Commonwealth Edison
One First National Plaza, Chicago, Illinois
Address Reply to Post Office Box 767
Chicago, Illinois 60690

April 7, 1975

SUBJECT: REVISION TO ABNORMAL OCCURRENCE REPORT ON DRESDEN UNIT 2 CORE SPRAY
INJECTION LINE THROUGH-Wall CRACK

10" CORE SPRAY NOZZLE

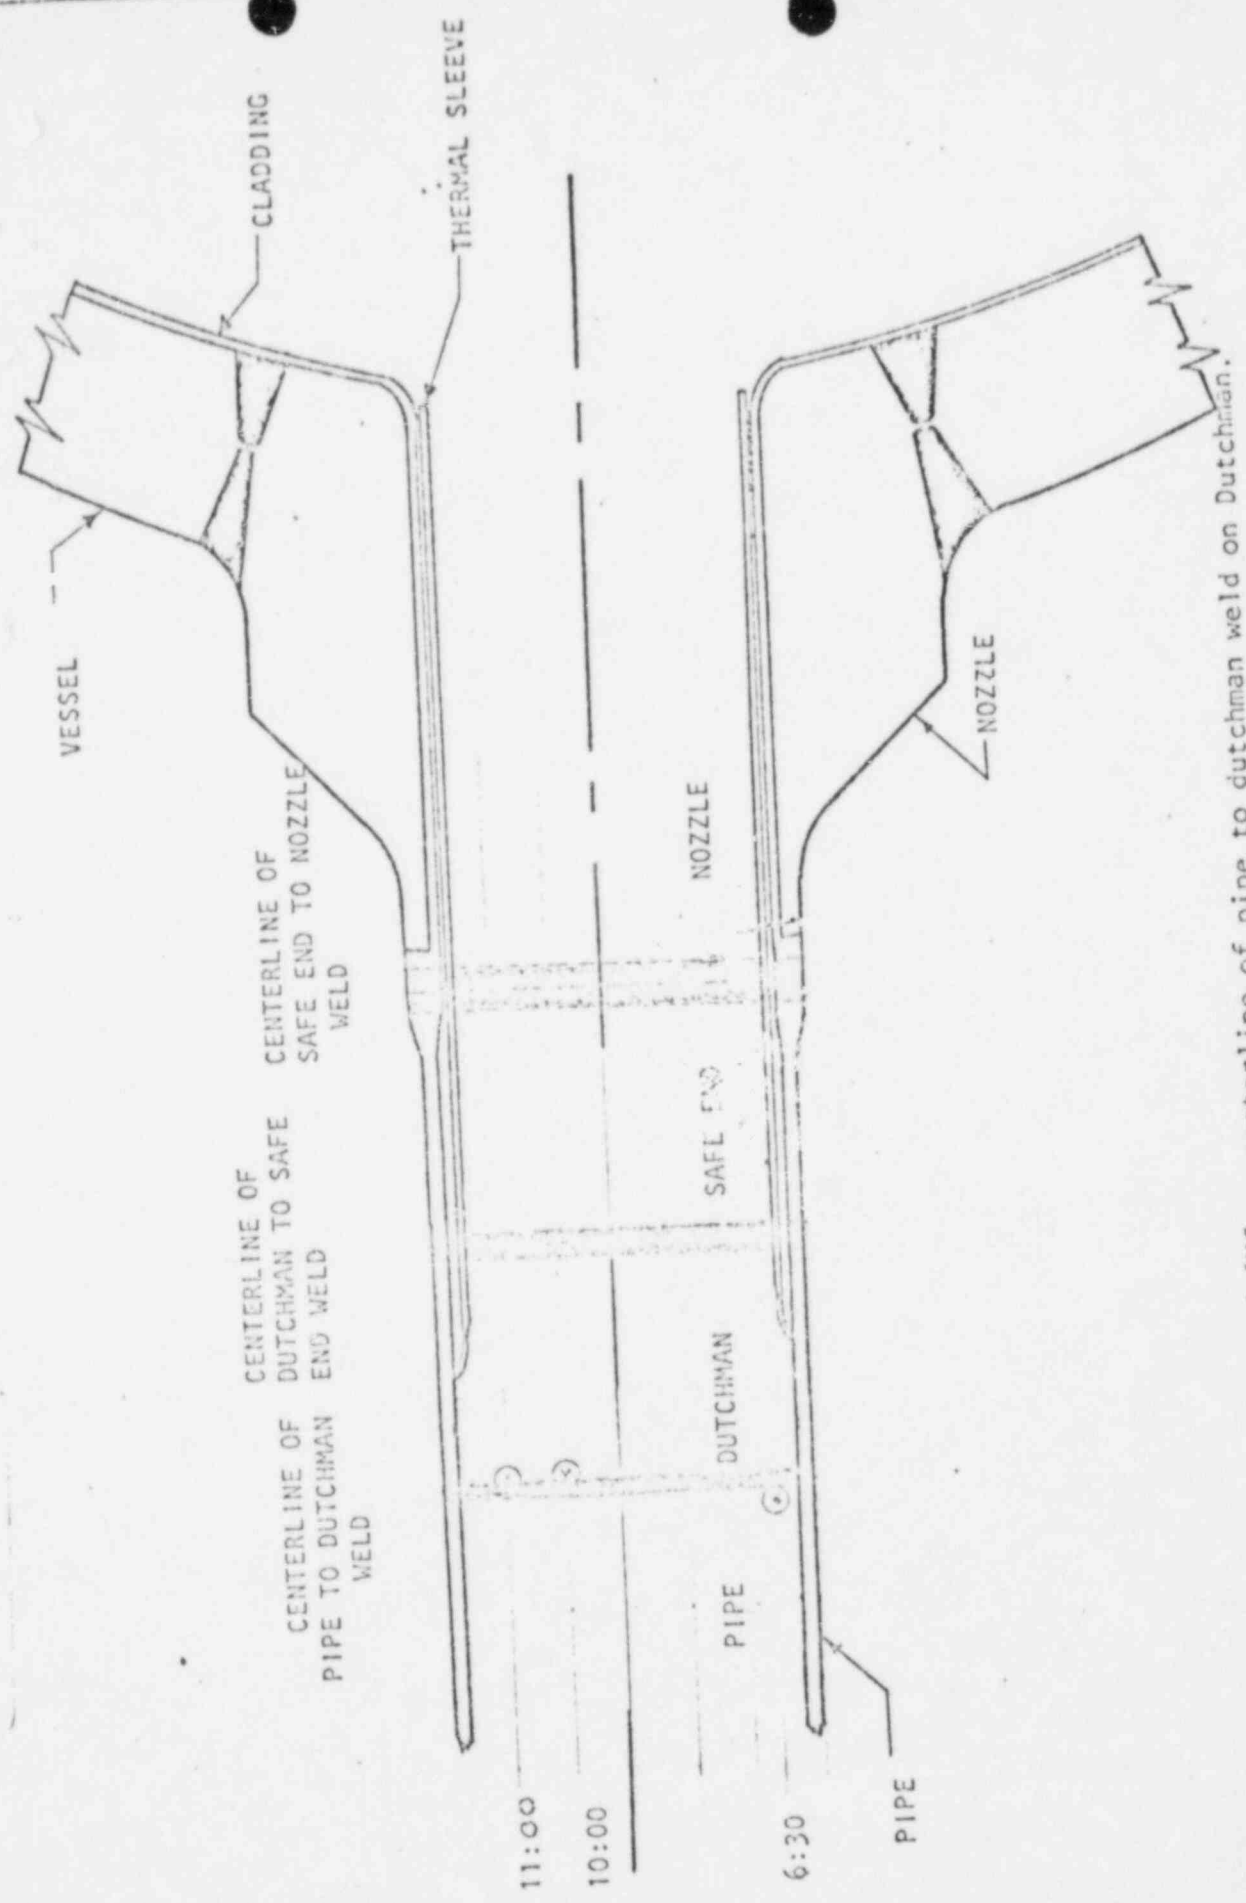
As a result of an inquiry into the actual location of the dye penetrant indications versus the weeper on Core Spray nozzle "B", the drawings were reviewed for their accuracy. It appears that the proper location of the indications are in error. In addition, on "A" Core Spray Nozzle drawing, the clockwise location of the visible weeper was also revised to reflect previously reported information. Attached are drawings of "A" & "B" 10 inch Core Spray nozzles with appropriate changes made.

- A⊙ - Location of weeper approx. 1/8" on pipe side of weld at 11:45
 B⊙ - Location of crack approx. in centerline of Dutchman to Safe End weld at 3:00-9/16" in Length.
 C⊙ - Location of crack approx. in centerline of Dutchman to Safe End weld at 8:00-5/8" in Length.

- ②- Location of weeper indication approx. 5/16" from centerline of pipe on pipe side.
- ③- Location of PT indication approx. 5/8" from centerline of weld on pipe side.
